STATE WATER CORPORATION CHAFFEY DAM AUGMENTATION AND SAFETY UPGRADE PREFERRED INFRASTRUCTURE REPORT

Appendix 5: Addendum Air Quality Impact Assessment

Chaffey Dam Air Quality Impact Assessment Response to Comments from NSW EPA

Figure 1 Time Series Plots of 24-Hour Average PM₁₀ Concentrations Predicted at Sensitive Receptors 7 and 8 – Revised Results

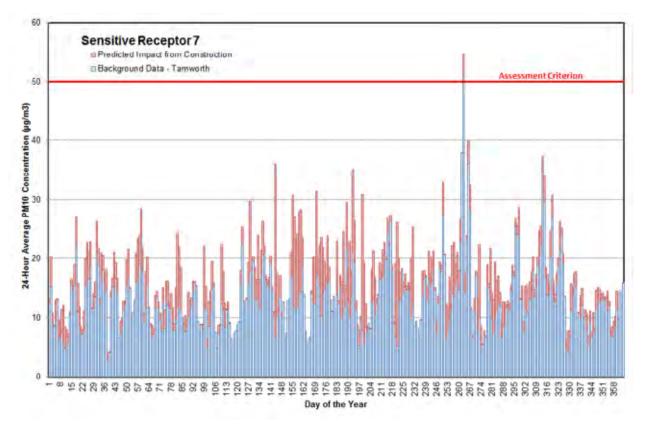
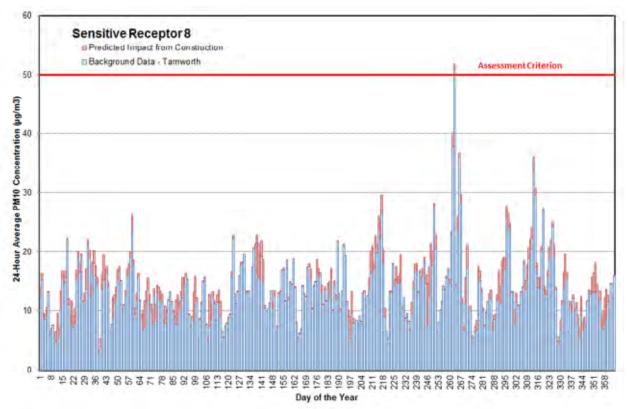
The recommendations made by the EPA (EPA submission, dated 30th January 2013, DOC13/2560) with regards to air quality were as follows:

- 1. Revise the AQIA to include additional particle mitigation strategies so that predicted air impacts at all sensitive receptors meet EPA assessment criteria. Any additional particle emission controls must be consistent with best practice.
- 2. Develop and implement an air quality management plan (AQMP) for the Project. The AQMP will require the following information for each pollutant and emission source:
 - *key performance indicator;*
 - monitoring method;
 - location, frequency and duration of monitoring;
 - record keeping;
 - response mechanisms; and
 - compliance reporting.
- 3. Provide further details of each proposed mitigation strategy to ensure the effective implementation of each strategy can be demonstrated, consistent with the above requirements.

While the cumulative 24-hour PM_{10} and $PM_{2.5}$ concentrations do show one exceedance per annum being predicted for all receptors, this is due the background PM_{10} and $PM_{2.5}$ files containing one exceedance. The predicted incremental impacts from the road construction activities, once revised to account for the reduced activity rates and additional control measures, do not result in any additional exceedances being predicted at any receptors. This is illustrated in the time series plots of the 24-hour average PM_{10} concentrations predicted at sensitive receptors 7 and 8 shown in **Figure 1**.
